Credit Procedures For Recall 9184

Figure 1. Rear Master Cylinder Brake Line (exhaust removed for clarity)

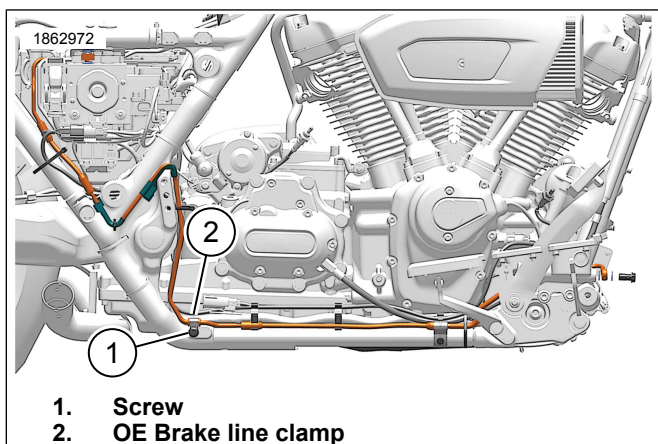
3. See Figure 1. Remove and retain screw (1).
4. Remove and discard Original Equipment (OE) brake line clamp (2).
5. See Figure 2. Install **new** P-Clamp (3) from recall kit (Part No. 91500116).
 - a. Make sure P-Clamp (3) is properly orientated.
6. Install screw (1). Tighten.
Torque: 9–11 N·m (80–97 **in-lbs**)
